LOCATION Langstaff Rd. Underpass

**DYNAMIC MONITORING OF PILES
LANGSTAFF ROAD BRIDGE
OVER HIGHWAY 400
TOWN OF VAUGHAN, ONTARIO**

Re: Langstaff Road Underpass
W.O. #90 11-001, Site 37-1298
Hwy. 400, District 6, Toronto

The General Arrangement Drawing for the above mentioned structure has been reviewed by the Region, Structural head Office and the Foundation Design Section. Comments received are indicated on the enclosed plan or as listed below. The Foundation Design Section also reviewed the Foundation Investigation Report.

PLAN

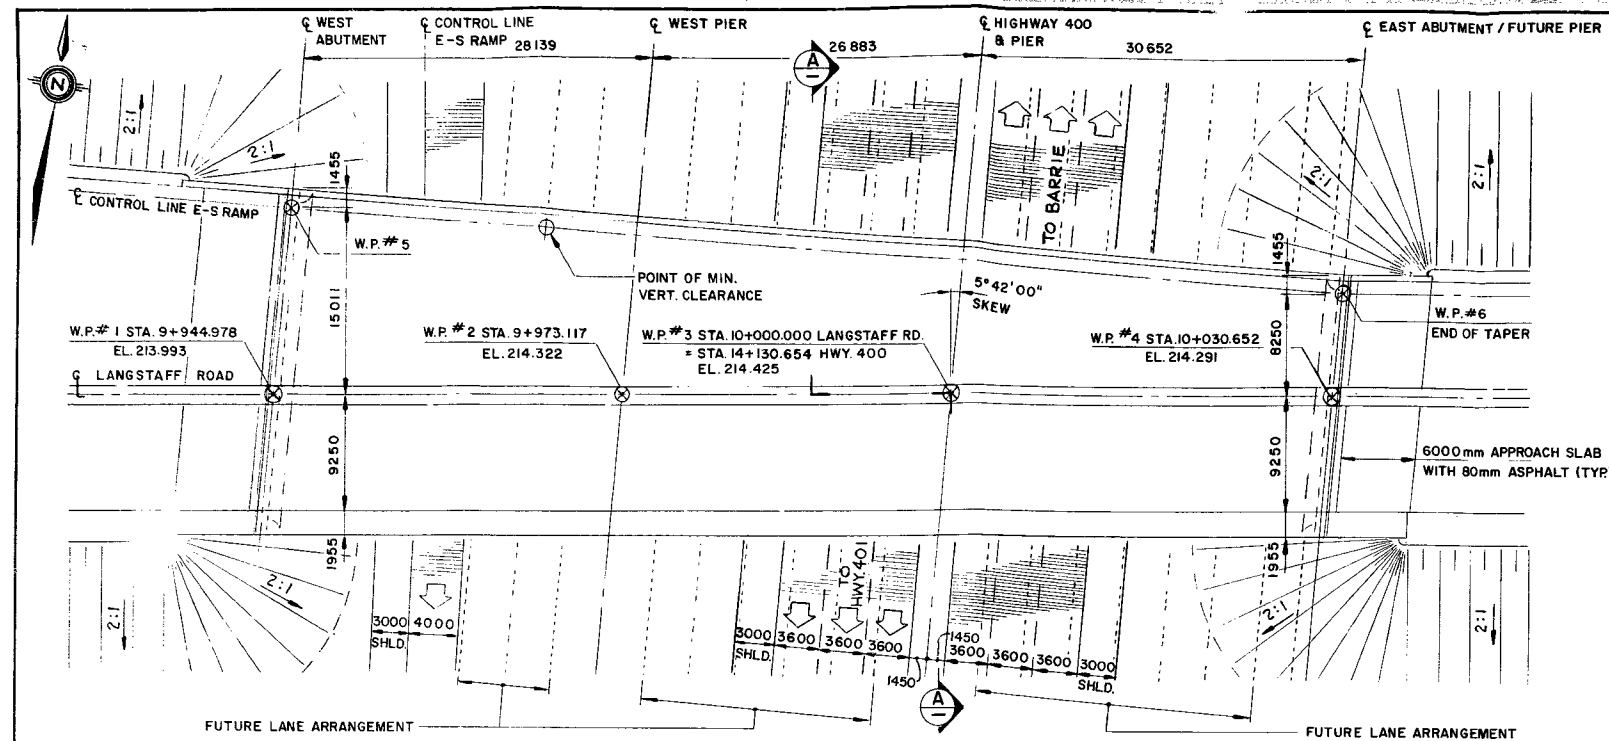
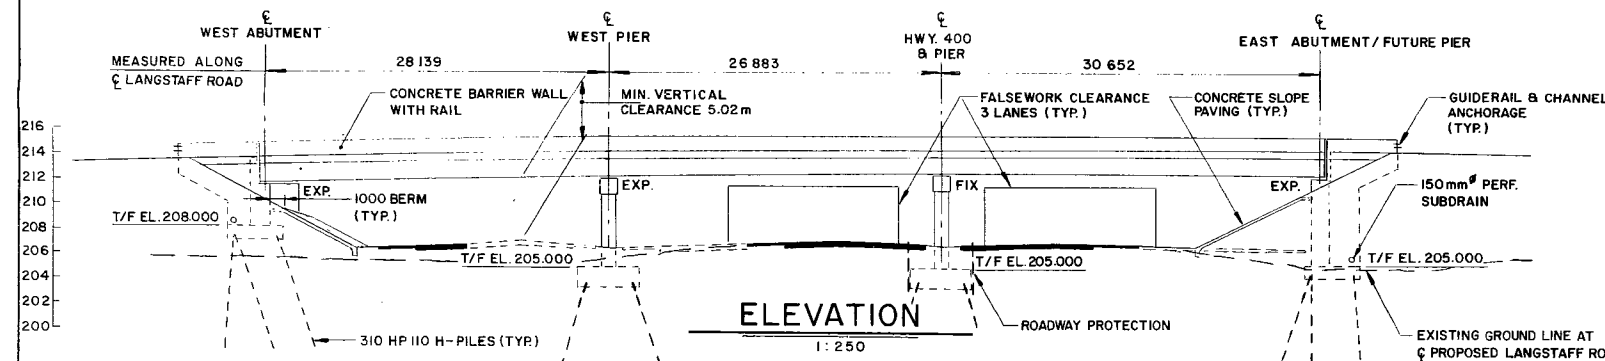
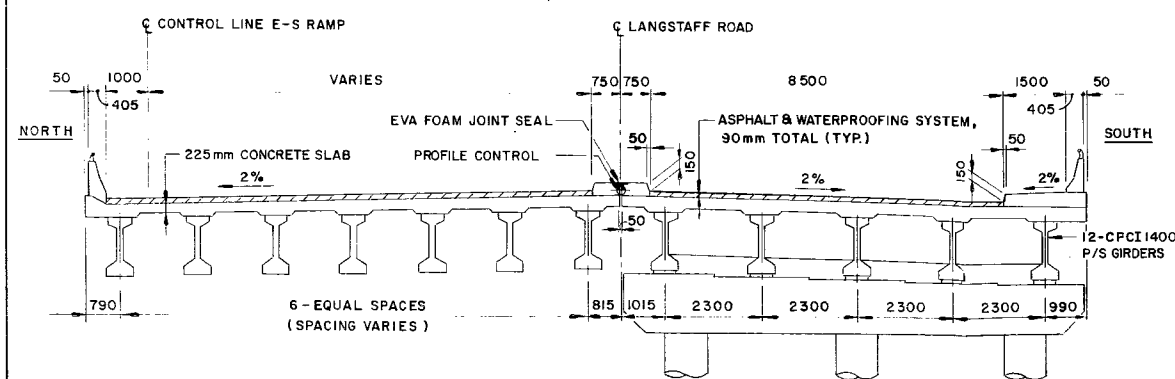
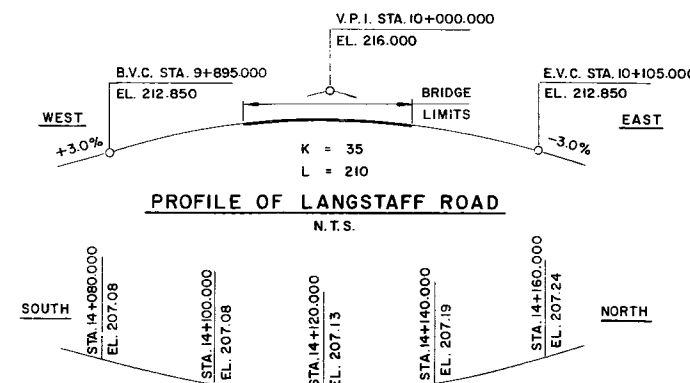
1. Use at-rest pressures for the abutment design if the piles are less than 5 metres in length.
2. Use a shear block at the abutments to resist transverse forces.

2. If retaining walls are required, consideration should be given to reinforced earth retaining structures.
3. M.T.O. practice is to specify material parameters for granular backfill rather than provide equivalent fluid pressures.
4. Although deep-seated instability of the 8.5 m approach fills is not anticipated, the surficial stability of the high fill should be addressed.
5. Since groundwater elevations have been reported to be higher than proposed excavations and the non-cohesive strata are susceptible to disturbance, dewatering recommendations are required.
6. Recommendations for the proposed roadway protection scheme are required.
7. Recommendations for anticipated settlement under the approaches should be provided.

- M.T.O. practice is to specify material parameters for granular backfill rather than provide equivalent fluid pressures.
- although deep-seated instability of the 8.5 m approach fills is not anticipated, the surficial stability of the high fill should be addressed.
- since groundwater elevations have been reported to be higher than proposed excavations and the non-cohesive strata are susceptible to disturbance, dewatering recommendations are required.
- recommendations for the proposed roadway protection scheme are required.
- recommendations for anticipated settlements under the approaches should be provided.

However, the main issue is whether or not the use of steel H-piles to support the piers and abutments is the most appropriate and cost-effective solution for the foundations at this site. On the basis of Golder Associates' investigation and the difficulties associated with spread foundations outlined in the attached submission, we are of the opinion that the use of steel 'H' piles at all piers and abutments is the correct decision for this project. Accordingly, the design has now been completed on this basis.

Bank seat construction involves placement of Granular A fill material compacted to 100 per cent Standard Proctor within a zone as defined in the attached Figure 1. The factored bearing capacity at ULS for footings constructed as indicated in the figure may be taken as 800 kPa. The coefficient of friction between the footing and the granular fill may be taken as 0.46 and 0.55 at ULS and SLS, respectively. The settlement of footings constructed within the embankment is relatively insensitive to the bearing pressure applied but is directly proportional to the settlement of the embankment fill and of the subsoils below the embankment. It is expected that the settlement of compacted Granular A will be completed by the time the footings are constructed however consolidation of the silty clay foundation soils will be ongoing under the embankment loading. It is estimated that up to 80 mm of settlement of the footing due to consolidation of the 3 m thick deposit of silty clay could occur.
